Response to the Reviewers' Comments

The authors would like to thank the reviewers for the precious comments and suggestions on the technical contents and presentation of our manuscript "Runtime Power Management of Battery Electric Vehicles for Extended Range with Consideration of Driving Time," submitted to IEEE Transactions on Very Large Scale Integration (TVLSI.) This revised manuscript has been greatly improved thanks to the reviewers' invaluable advices. We have revised the manuscript faithfully following the reviewers's comments. We include the newly added or significantly modified parts in the revised version of the paper also in Response to Reviewers. We highlight the important technical content changes and set those parts in a red color in the revised paper.

Fig. 2: (a) Range-speed experimental data for Chevrolet Bolt [36] and (b) comparison with simulation results of the proposed EV power model.

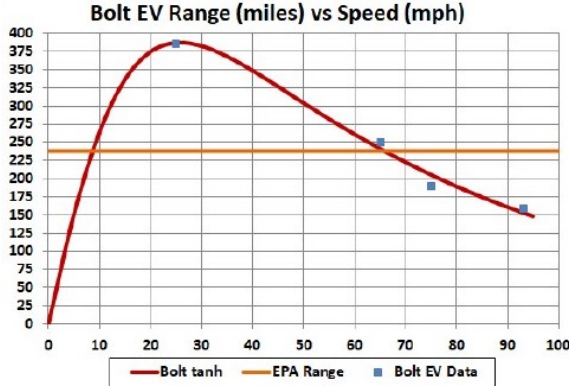
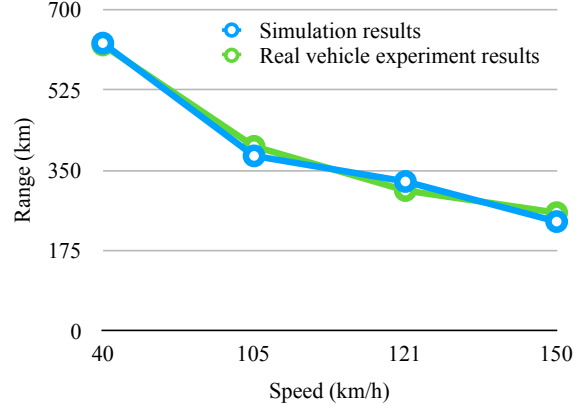
R1-C2 It is not clear how to validate the power model of EV. As the author mentions that accuracy of power model is quite important, it is good to see the power model in this paper can be validated by some real measurement results.

We further evaluate the model accuracy with the range-speed real vehicle experiments as shown in Fig. 2(a) to confirm the derived power models are close enough to the real vehicle measurement data [32], [33], [34], [35], [36]. We refine the coefficients until all the available data values match well.

As a result, the derived EV power model well matches with the range-speed experimental data as shown in Fig. 2(b) as well as the top speed and maximum acceleration setting the aerodynamic resistance, rolling resistance, curb weight, etc. with the known values. The errors in the range-speed simulation is merely 1.4%, the time for 0-to-100 km/h error is 7.8%, and the top speed error is 3.0%, respectively. We revised the manuscript adding the following paragraph with a new figure in Section III.A on page 3 and 4.

We further evaluate the model accuracy with the range-speed real vehicle experiments as shown in Fig. 2(a) to confirm the derived power models are close enough to the real vehicle measurement data [32], [33], [34], [35], [36]. We refine the coefficients until all the available data values match well.

As a result, the derived EV power model well matches with the range-speed experimental data as shown in Fig. 2(b) as well as the top speed and maximum acceleration setting the aerodynamic resistance, rolling resistance, curb weight, etc. with the known values. The errors in the range-speed simulation is merely 1.4%, the time for 0-to-100 km/h error is 7.8%, and the top speed error is 3.0%, respectively.

Fig. 12: Velocity profile comparison with EDP , E^2DP and E^3DP on Serrano Avenue in Anaheim Hills.

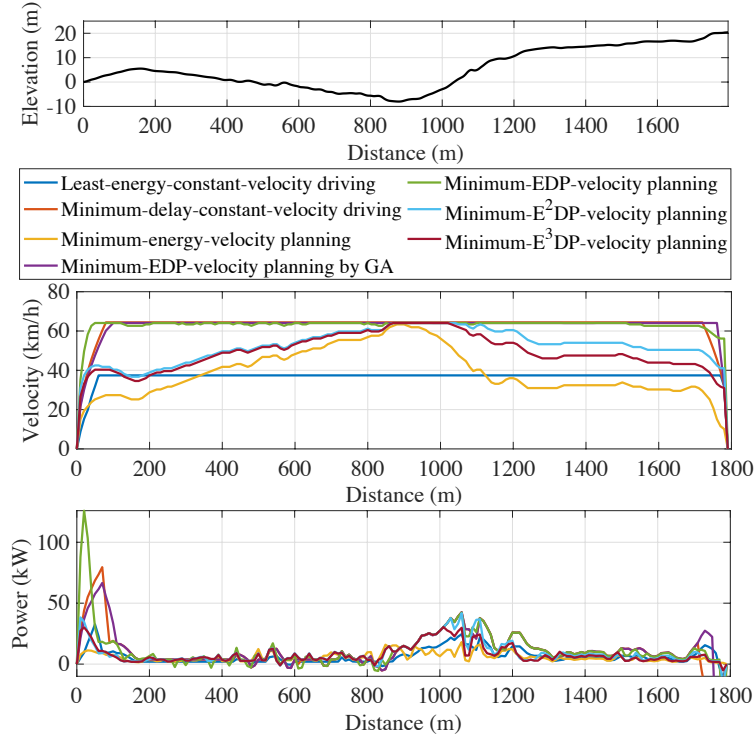
R1-C3 The optimality of the proposed scheduling algorithm is unclear. The author should add several paragraphs to discuss this topic. It is also to see the comparison baseline is well accepted to show the advantage of the proposed algorithm.

We also updated Fig. 12 and Fig. 13:

Fig. 11: Histograms of velocity and acceleration for the proposed energy-aware-velocity planning methods without an acceleration constraint (a) and (b) and with an acceleration constraint (c) and (d), respectively.

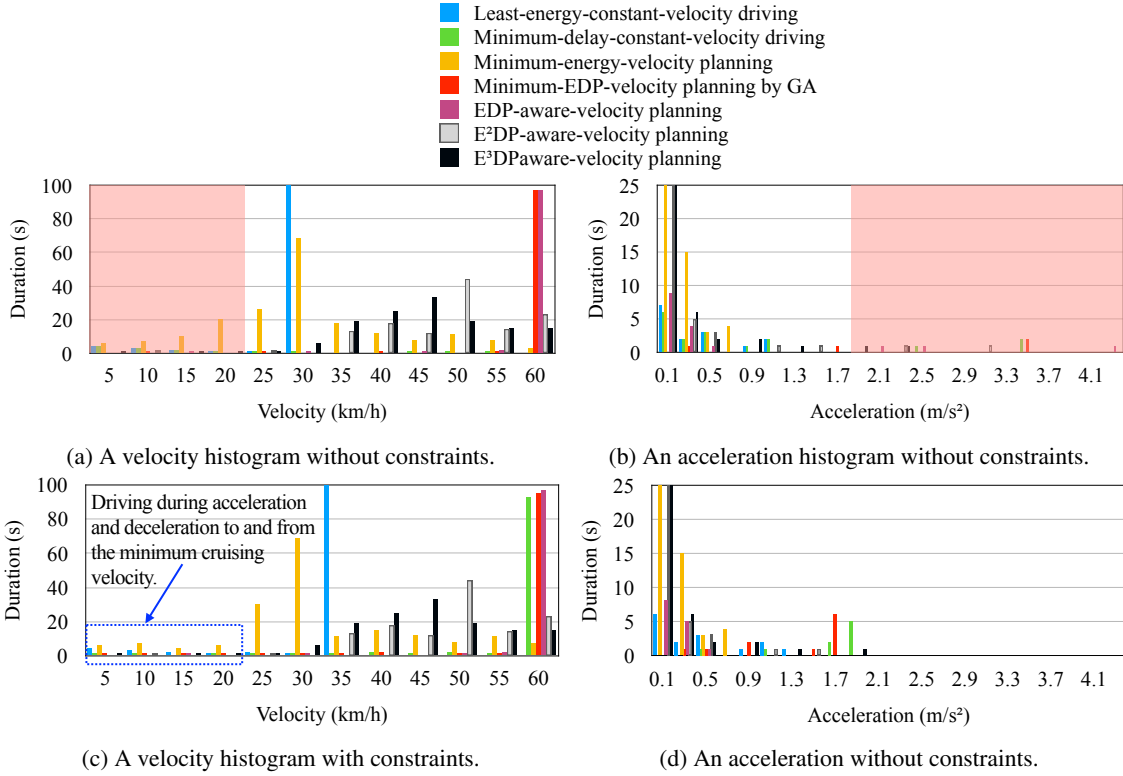
R2-C2 It would be good to have more discussion on the assumptions of the approach and the experiments, e.g., how much can the velocity be changed in practical scenarios without impeding traffic and causing unsafe situations (also depending on the road conditions and whether it is urban or rural environment I suppose). Currently, there only seems to be one constraint on not slower than 10 km/h.

We quantize the velocity and acceleration values and make a histogram to analyze population of velocity and acceleration for the proposed energy-aware-velocity planning methods. Fig. 11(a) and (b) show two histograms of the driving schemes in Fig. 12, which do not have velocity and acceleration constraints. We avoid a cruising velocity lower than 25 km/h and an acceleration higher than 2.0 m/s^2 in this paper without loss of generality. The acceleration of 2.0 m/s^2 is the same as the maximum acceleration of compact cars designed to be used primarily used in urban areas (13 seconds of 0-to-100 km/h time).

Fig. 11(c) and (d) shows the velocity and acceleration histograms with the constraints. Once we run the DP for the first time without constraints, we analyze the histogram, adaptively determine the minimum cruising velocity and maximum acceleration constraints, and run DP again. We keep the same constraints for online recomputation whenever unexpected interrupts occurs.

Fig. 8: Altitude changes in the real road benchmarks.

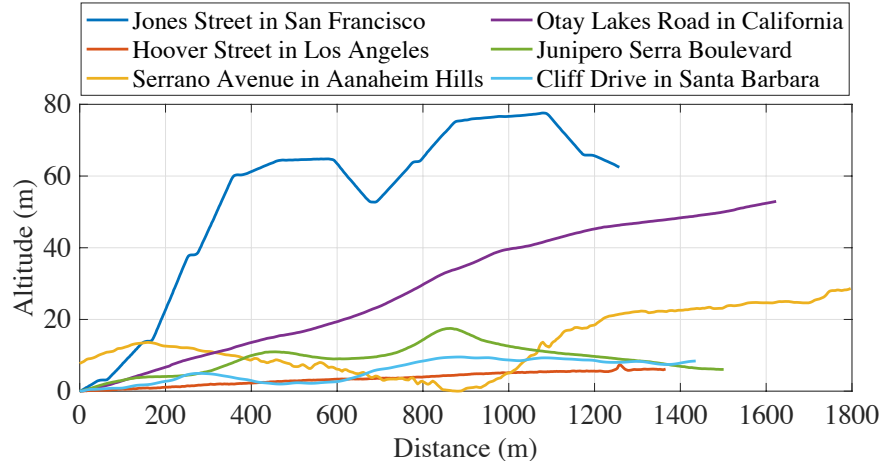
R2-C3 Related to the last point, it would be good to have more discussion on the road benchmarks, e.g., how they are generated and how representative they are. The optimization results significantly depend on road slope. It would be good to use a variety of real road segments for testing.

R2-A3 We appreciate the reviewer's comment. We replaced the previous synthetic road benchmarks with the real road benchmarks. We made six new real road benchmarks from various locations in California. The first three roads are in cities. Jones Street in San Francisco and Hoover Street in Los Angeles are two representative city landscapes such as hills and flat roads, respectively, and Cliff Drive in Santa Barbara is a mixture of those. The second two roads are in mountain areas: Serrano Avenue in Anaheim Hills and Otay Lakes Road in San Ysidro Mountain in California. The last road is Junipero Serra Boulevard connecting San Francisco and San Jose. The details of road data is summarized in Table II, and Fig. 8, which visualize the altitudes of the road benchmarks. We also revised all the associated contents with the new real road benchmarks.

We choose six roads from various locations in California and make real road benchmarks. The first three roads are in cities. Jones Street in San Francisco and Hoover Street in Los Angeles are two representative city landscapes such as hills and flat roads, respectively, and Cliff Drive in Santa Barbara is a mixture of those. The second two roads are in mountain areas: Serrano Avenue in Anaheim Hills and Otay Lakes Road in San Ysidro Mountain in California. The last road is Junipero Serra Boulevard connecting San Francisco and San Jose. The details of road data is summarized in Table II, and Fig. 8, which visualize the altitudes of the road benchmarks.
